Comments on NERC Draft GMD Standard TPL-007-1 – Overstatement of Peak dB/dt of Reference Waveform

Comments on NERC Draft GMD Standard TPL-007-1 – Problems with NERC Reference Disturbance and Comparison with More Severe Recent Storm Events

Unofficial Comment Form

Questions on Draft 1 of TPL-007-1

Figure 2 – Rate of Change of NERC Geomagnetic Disturbance Reference Field in nT per 10 Seconds.

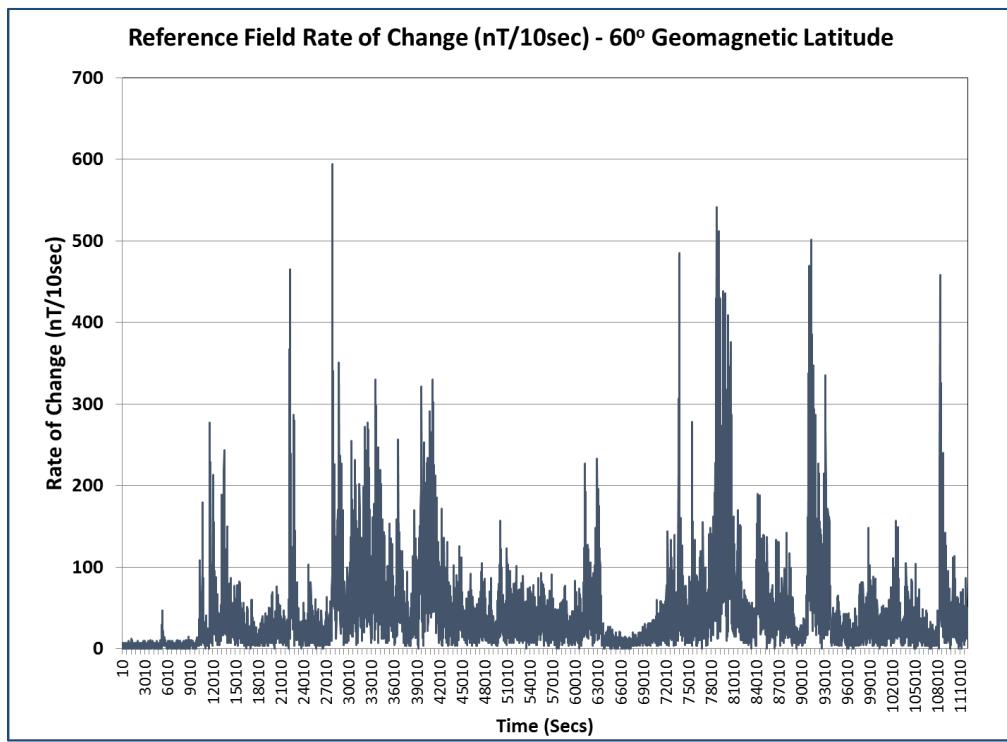
The NERC Geomagnetic Disturbance Reference Field was publicly provided on May 6, 2014 and has a time step cadence of 10 second time steps between data points. Figure 2 provides a plot of the total horizontal rate of change of the geomagnetic field (dB_h/dt) in terms of nT per 10 Second time steps. As shown in this graphic summary, the peak dB/dt approaches ~600 nT/10sec (more exactly, it reaches a peak of 594 nT/10sec at time step 27,870 seconds). The NERC GMD Standards Drafting Team apparently used the simple multiplication of 6 times the 594 nT/10sec to derive the 3,565 nT/min referenced in Figure 1. This is in error and does not obey the averaging protocol used in geomagnetic observatories around the world to derive the intensity observed in nT/min. It is only possible to reach a 3,565 nT/min intensity if the actual total nT change is equal to 3,565 nT over a time span of a minute duration.

In many cases the sharp ~500 to ~600 nT/10sec changes are not sustained over a time duration of a minute, hence the simple multiplication of these values by 6 to convert to nT/min will overstate the intensity greatly in these situations. This overstatement is clearly the case in the NERC Reference Field. If we take the reference field in 10 sec time steps and average each minute the dB/dt into true nT/min rate of change, the resulting dB/dt intensity is as provided in Figure 3. As shown in this proper conversion, the peak dB/dt is only ~2000 nT/min, not the NERC claimed 3,565 nT/min. It should also be noted that this adjustment further shifts the time point of this peak to a time that is much later in the reference storm, which is also at a time consistent with the estimated peak geo-electric field. Therefore this NERC characterization is incorrect and greatly overstates the equivalent nT/min intensity of the reference waveform and is also inconsistent with the peak geo-electric field data.

Figure 1-1 – Correlation of Geomagnetic Storms with reported GSU Transformer Failures.

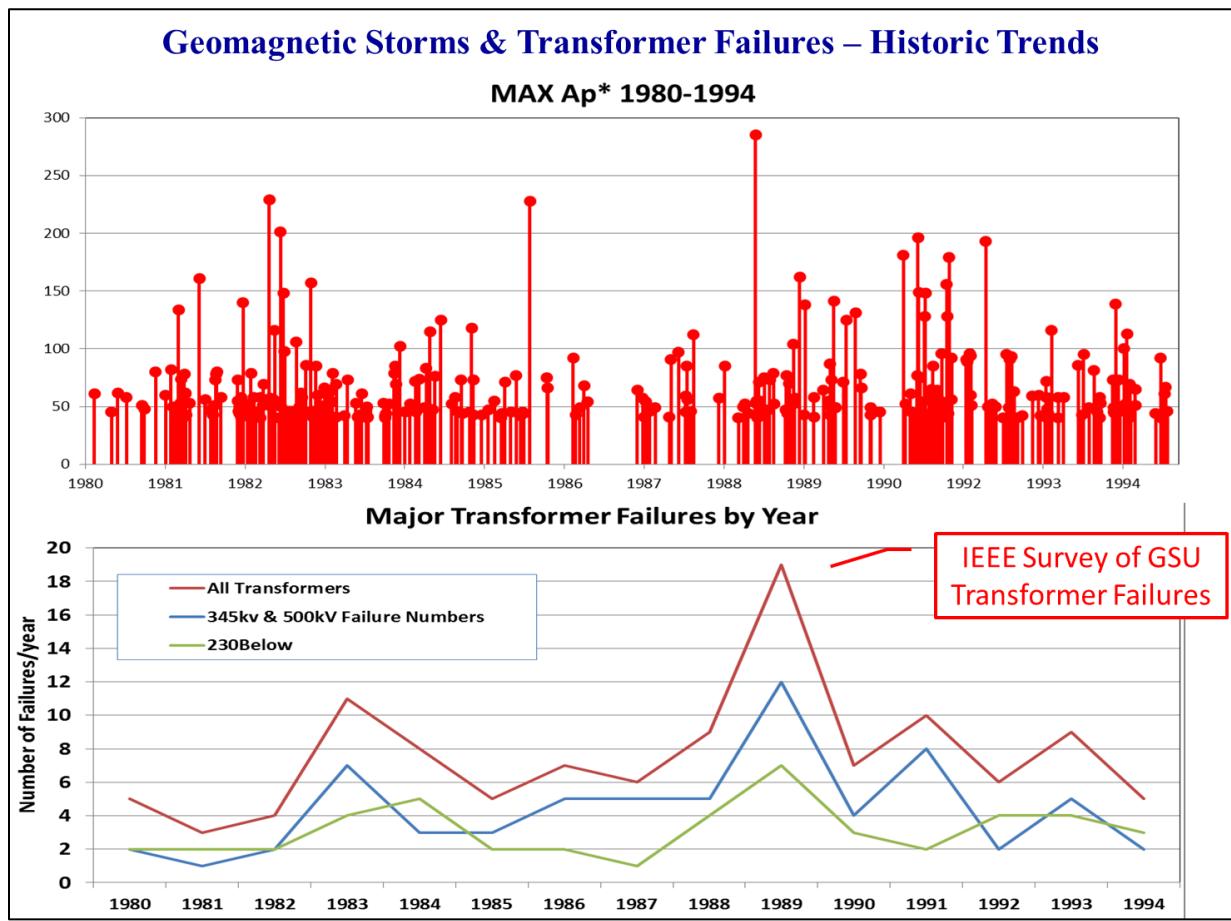
Examinations carried out using publicly available data from an IEEE GSU Transformer Failure Survey clearly show associations between prior GMD disturbances and failures of these transformers and was reported to the US FERC in a study performed by Storm Analysis Consultants. This report illustrates that the major root-cause of failures of these transformer failures over the period of 1980-1995 is likely due to specific GMD events. Further these GMD events were much smaller than the most severe GMD events that are now understood to be possible to occur across the US bulk transmission electric grid. Figure 1-1 provides a comparison plot showing Geomagnetic Storms (top as measured by Ap* index) and discrete GSU transformer failures that are reported over a period from 1980-1995. Three major storms (July 1982, Feb 1986 and March 1989) all produce increases in transformer failures in their aftermath. Further these scale in a dose/response rate to reported db/dt levels of each storm. The highest being the 1989 storm, the next highest the 1982 storm and last being the 1986 storm.

Because the survey included added information on the failure events, it is possible to understand the consequential dimensions of these failures in more detail. For example all of these events Post 1989 are major failures, requiring replacement of the transformer. Further when looking at the failure, other consequential impacts where noted, the most important being that for 27% of all reported failures resulted in a major transformer/substation fire event as well. This increased the degree of

Figure 2-1 – Transformer Manufacturer Estimates of Harmonic Currents in 765kV Transformer Main Windings due to GIC

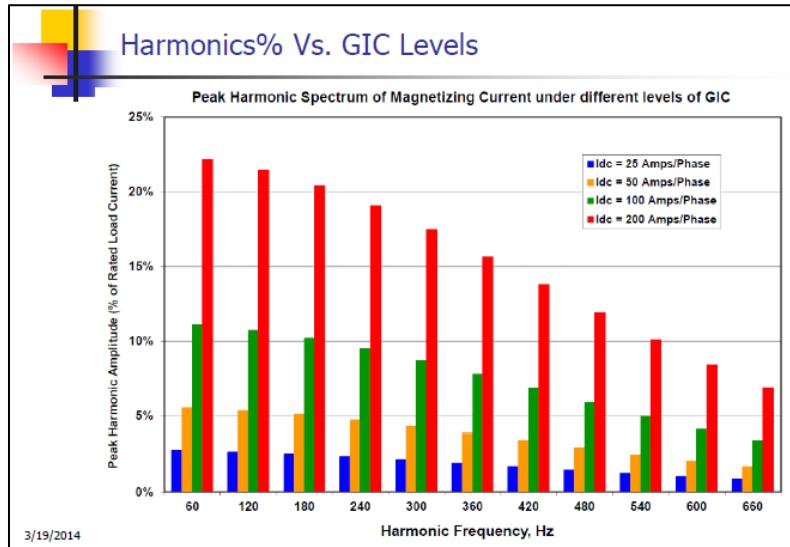
In the recent NERC GMD TF presentation (March 2014), a transformer manufacturer assessed a 765kV transformer for a transmission owner/operator for various levels of GIC flow. Figure 2-1 provides a summary of the Harmonics due to these various levels of GIC. As shown in this graphic summary, it is estimated that there will be substantial Zero Sequence Harmonics produced at the 3rd, 6th, and 9th harmonic frequencies.

Figure 2-2 – Tertiary Winding AC Current and 100MVA Current Rating Limits for 200 A/phase GIC in Main Windings.

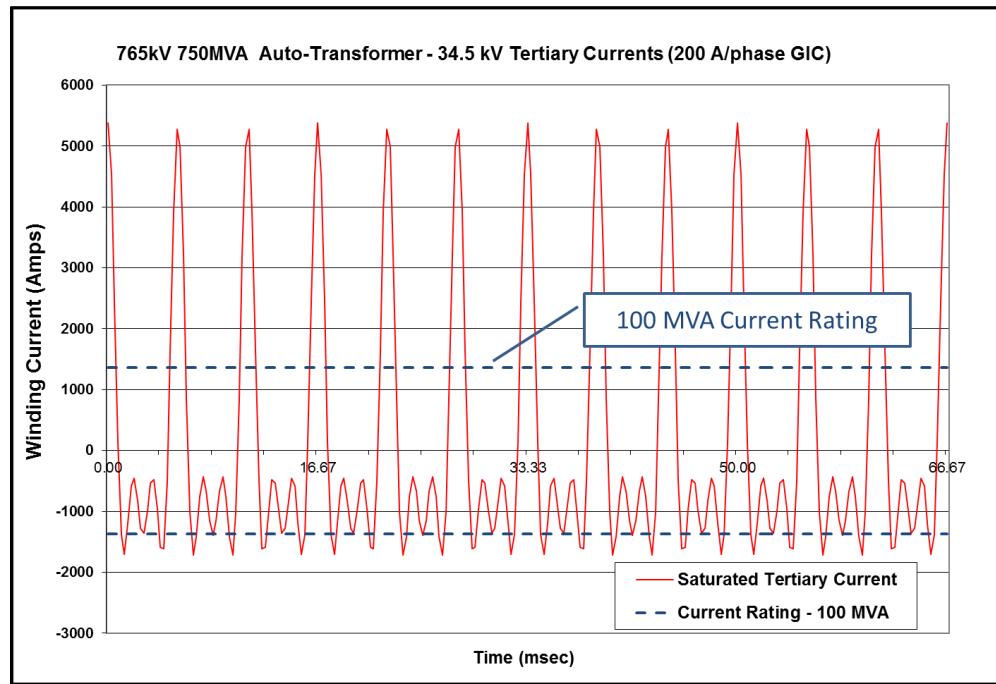
In the case of this particular transformer, the Main Winding has an MVA Rating of 750MVA, while the Tertiary Winding is 100MVA (i.e a 13.3% ratio, noting that ratios for even larger EHV transformers will typically be lower than 13%). In this particular case and for the 200 Amps/phase GIC level, the estimated Tertiary Winding AC Current Waveform using the harmonics from Figure 2-1 for this transformer is shown in Figure 2-2.

As this example illustrates, the waveform greatly exceeds the continuous current rating by as much as a factor of ~4. While these overloads would not be tolerable for a 60 Hz current, the reality of this case is that this example waveform consists of large components of 3rd, 6th, & 9th harmonics. Because of the harmonics this will greatly increase the winding losses (compared to same current at 60Hz), and winding heating from eddy currents and other stray loss factors. Tertiary Winding Losses can be calculated using the standard guidelines of ANSI/IEEE C57.18.10. Figure 2-3 provides a plot of the increase in Tertiary winding losses for increasing GIC levels using the inputs provided by the transformer manufacturer in Figure 2-1. As this plot illustrates, this tertiary winding will be subjected to enormous loss increases for increasing GIC. The losses will be highly concentrated in this winding accounting for more than 80% of all transformer losses. This high loss and heating concentration will greatly accelerate tertiary winding temperature increases as the rate of temperature rise is not a set “time constant”, but rather is a response to the excessively high rate of energy input in these windings compared to any other location within the transformer. This is a process which can rapidly cause winding/insulation system failures. The slower time delays assumed in other locations in the transformer main windings will not be accurate for this location.

Figure 2-5 – Increase in Tertiary Winding Temperature vs GIC for 13.3%, 10% and 7% Rated Tertiary Windings

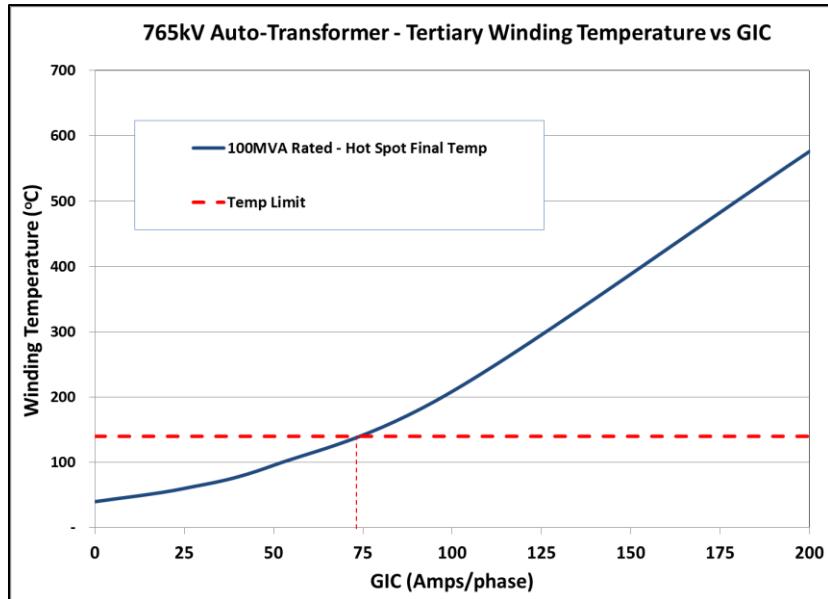
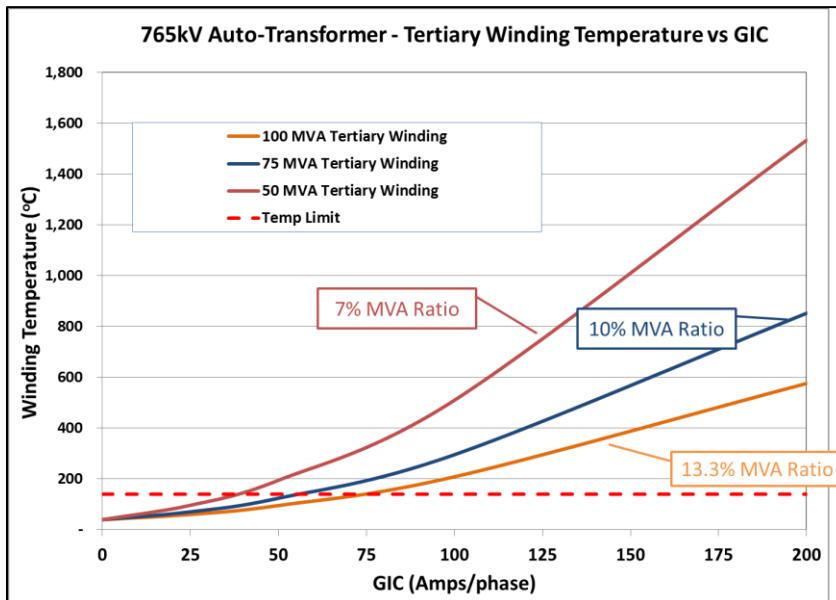
be reached in the tertiary windings for very low levels of GIC flow. In the Presentation to NERC, the manufacturer had concluded that this transformer could withstand much higher GIC levels, but had based this only upon examinations of the main windings and had not included these smaller MVA tertiary windings. The transmission operator noted that these particular tertiary winding MVA ratings were relatively large in their network compared to other transformers that would have tertiary windings with lower MVA ratings. This suggests that even more severe limitations would exist in these other network transformers. As noted, this 100 MVA tertiary was rated at 13.3% of the Main Winding MVA, to examine the impact on lower rated Tertiary windings, the same set of calculations were carried out for 10% (75 MVA) and 7% (50 MVA) tertiary windings. These results are presented in Figure 2-5.

As expected, in Figure 2-5, a decreasing Tertiary MVA rating results in a proportionately higher winding temperature risk for the same level of GIC. The main windings and GIC flows of the main windings are what determine the harmonics produced by saturation. The zero sequence harmonics in the tertiary will be “fixed or controlled” based on the voltage turns ratio of the main winding to tertiary. The MVA rating of the tertiary is not a limiting factor for this transformation, but as the MVA rating of the tertiary decreases, the onset of overload and resulting over-temperature conditions will be proportionately reduced. As previously noted, the general trend in the industry is to specify a smaller % MVA rating for the tertiary winding as the MVA rating of the EHV transformer increases. In some cases the tertiary rating can be below 5% of the main winding. Unfortunately it is also these large MVA EHV autotransformers that are most likely to be exposed to high GIC flows in the network. This design trend therefore acts to heighten the risk of damage to these transformers for severe geomagnetic storm events.

Figure 1-4 - Actual BSL Observation on March 13-14, 1989 for New Orleans location

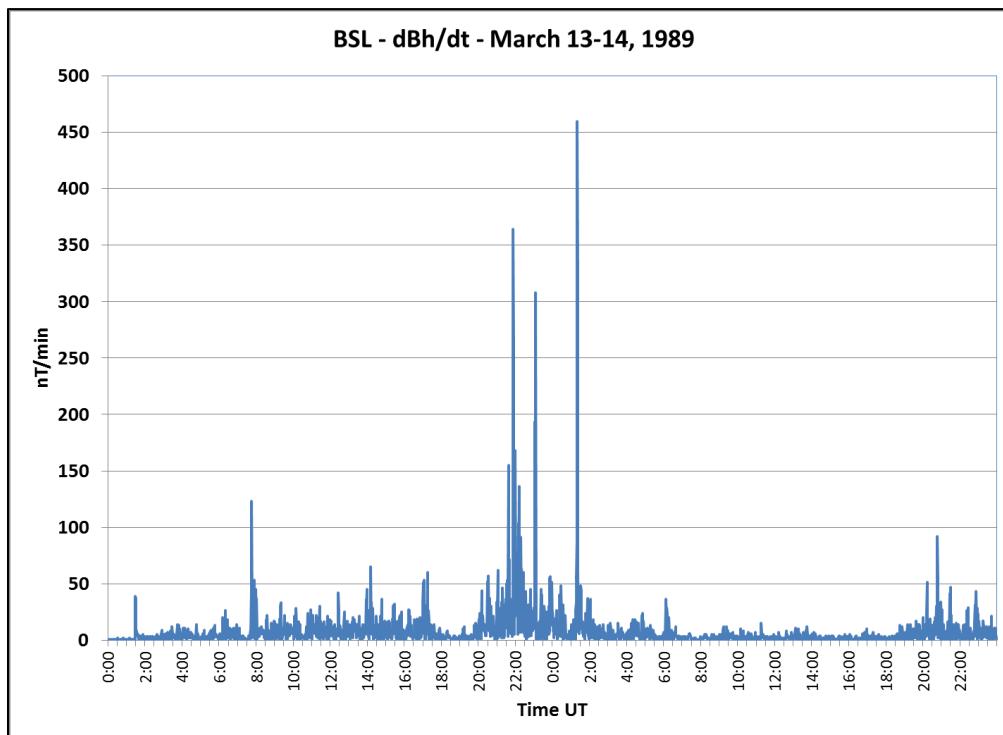
In the case of latitudes at New Orleans, the peak dBh/dt would be scaled to 10% of this $\sim 1950 \text{ nT/min}$ peak, resulting in a peak dBh/dt of the scaled reference field of $\sim 195 \text{ nT/min}$. Figure 1-4 provides a plot of the dBh/dt that was actually observed in the New Orleans region from the nearby Bay St. Louis magnetic observatory during the March 13-14, 1989 storm. As shown in this storm data, the BSL observatory experienced a peak dBh/dt of 460 nT/min . As a result, the proposed NERC scaled reference waveform would underestimate what was actually observed in the region by over a factor of two (2).

As this comparison illustrates, the NERC Scaling formula which adjusts the reference waveform to more southerly locations is not correct for this storm and should be called into question for a much larger storm of the 1-in-100 year class. Rather than providing “conservative” characterizations of the disturbance conditions, the NERC scaled waveform formula produces unrealistically optimistic waveform intensities.

Figure 2-10 - LOVO dBh/dt on July 13-14, 1982

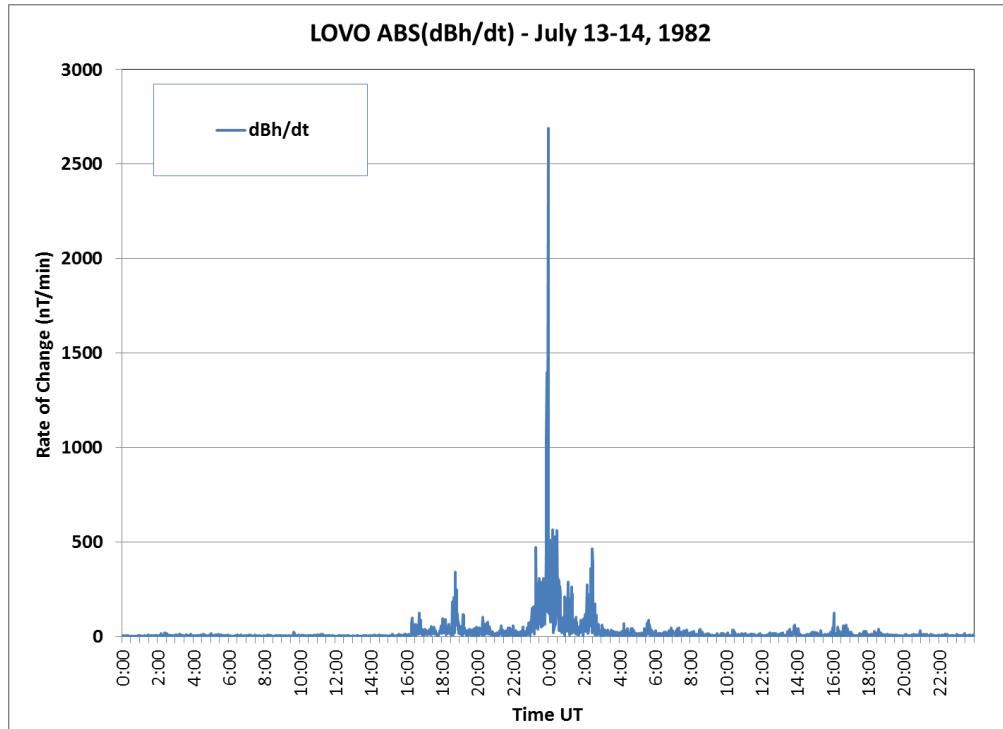
the dBh/dt impulsive disturbance reached an intensity of 2688 nT/min. This level is ~ 2.3 times larger than the proposed GMD standard waveform.

Figure 2-11 – Observed 2200 nT/min impulsive disturbance over North America on August 4, 1972 (from Anderson, Lanzerotti, et. al.).

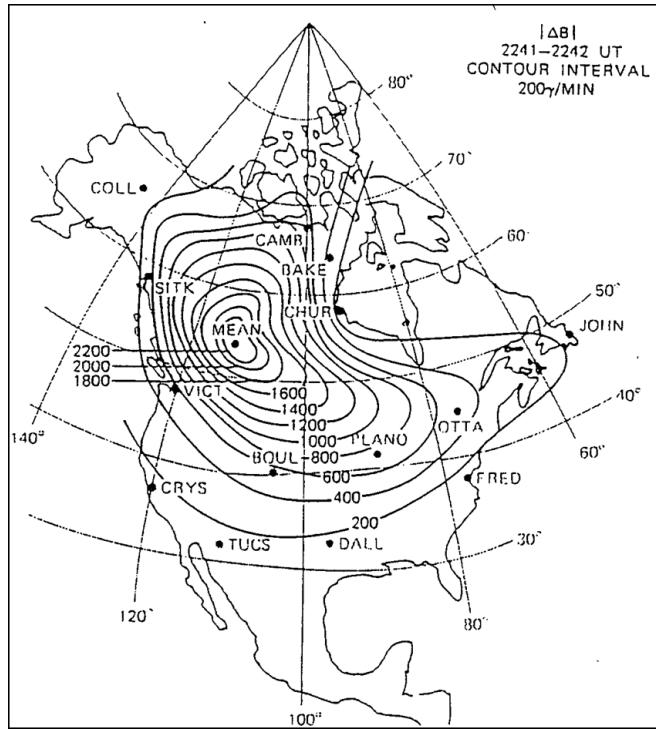
Historically, it is known that large impulsive events have occurred over North America. Figure 2-7 provides a map of the morphology of a large ~ 2370 nT/min event at 22:41UT on August 4, 1972 which was positioned over the western half of North America. This is a level that is over 20% higher than the proposed NERC reference field rate of change intensity at 60° geomagnetic latitude.

Figure 3-12 – From NERC GMD Standard Summary, Spatial averaging

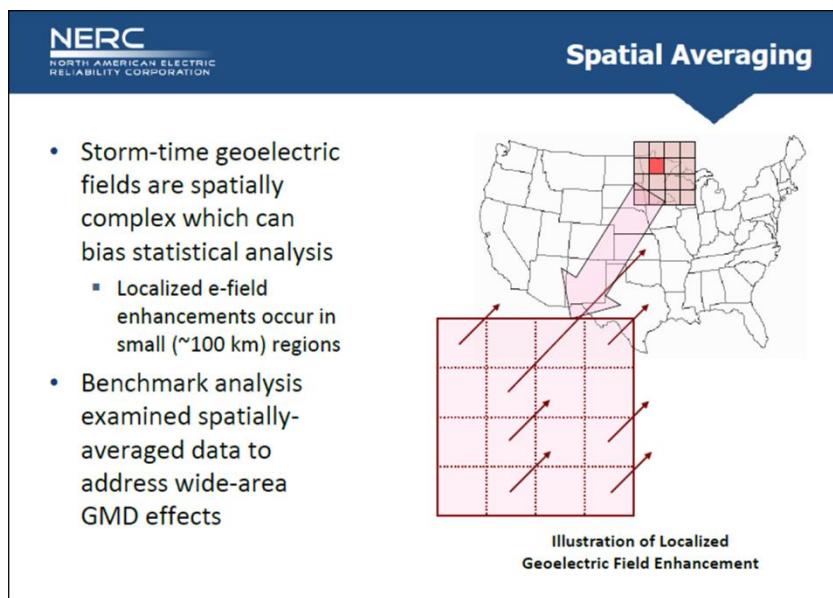
From the NERC GMD Standard summary, Figure 3-1 notes that NERC has determined that impulsive disturbances during benchmark storms will have relatively small regions (~ 100 km). We question the extent that this position is reliable or can be relied upon in standard setting based upon known large storms events over just the past few decades. Such determinations of small spatial averaging would not follow from analysis of the storm large impulsive disturbance environments itself, nor are we aware of any comprehensive assessment of US ground conductivity behaviors that would support such conclusions at this time.

As was previously noted in Figure 2-7 on August 4, 1972, the geographic footprint of a large impulsive disturbance can be enormous. Data on the geographic extent of these large dB/dt disturbances can also be extracted from the March 13-14, 1989 and July 13-14, 1982 events also discussed in Section 2 of these comments. In the case of the March 1989 storm, the large dB/dt disturbance of 1968 nT/min at 21:44UT at Brofelfde was also accompanied by the simultaneous observation of a dB/dt intensity at Eskdalemuir observatory in Scotland of 978 nT/min at 21:44 and 1092 nT/min at 21:45UT. This observatory is ~ 935 km east of Brofelfde and the closest observatory in that direction from Brofelfde. The

Figure 2: Snapshot of Geoelectric Fields of 1921 Railroad Storm GMD event (Source: Storm Analysis Consultants).

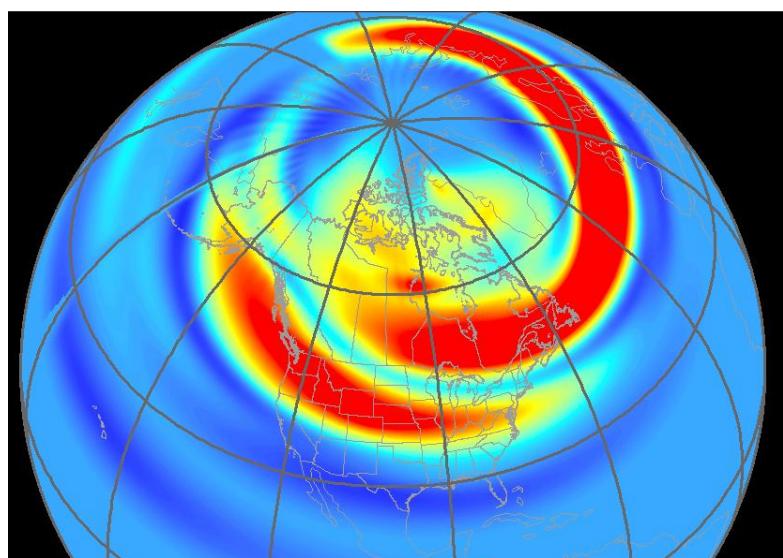
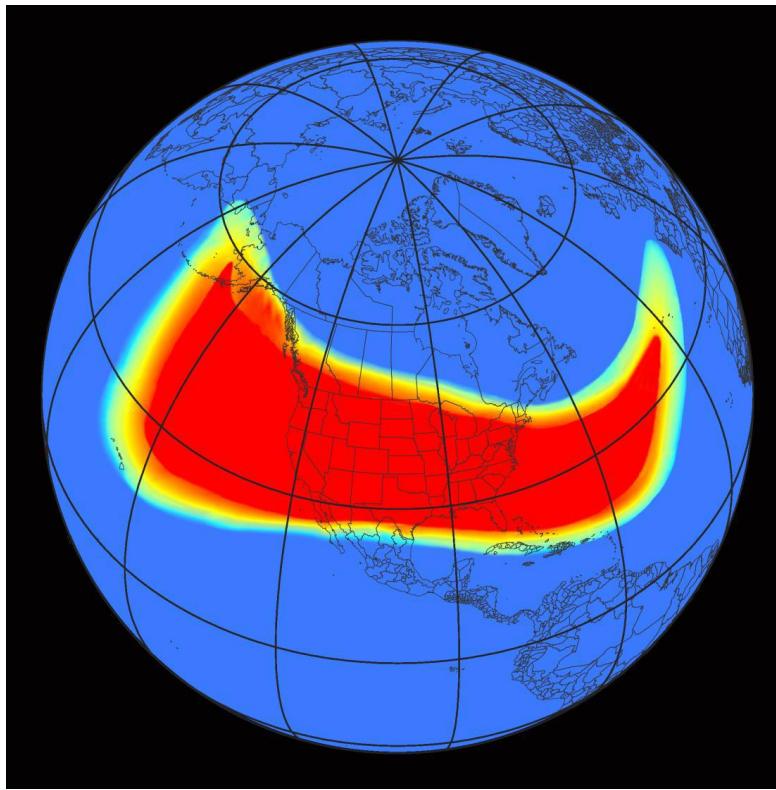
The use of the 1989 Quebec Storm as the benchmark event is of concern because simply scaling the field strengths of the 1989 Storm higher (an “intensification factor” of 2.5 is used), but leaving the same geographic footprint, does not appear to be a valid approach. While the 2.5 scaling factor is described to produce local “hot spots” of 20 V/km, in agreement with earlier findings, it fails to consider the well-known GMD phenomena that the electrojets of larger storms shift southward, as can be seen in comparing the two figures. By using the geographic footprint of the 1989 storm, the new benchmark will predict geoelectric field levels that are incorrect for geomagnetic latitudes below 60 degrees, where the center of the new benchmark storm has been set.

As the figures above show, GMD events larger than the 1989 Quebec event are expected to be larger in overall geographic laydown (continental to global in scale), and also to be centered at lower geomagnetic latitudes than the 1989 storm, due to a southward shifting of the auroral electrojet for more energetic storms. While the latitudinal scaling factor α may be correct for a storm like the 1989 Storm and centered on 60 degrees geomagnetic latitude, use of these scaling factors does not appear to be valid for GMD events where the storm will be centered at a lower latitude, and have a larger geographic footprint. While the β factor - which captures differences in geologic ground conductivity - will remain valid under all storm scenarios, the α factors would only be valid for a storm centered at 60 degrees. For example, in looking at figure 2 above, the storm is quite large, and centered at (roughly) 40 – 45 degrees North Latitude. The correct α factor for 45 degrees in this case would be 1, rather than the 0.2 value that would be correct for a storm centered at 60 degrees North Latitude. As it is not known what the center latitude of any given storm center would be, it would seem that the use of the α scaling factor is not supported.
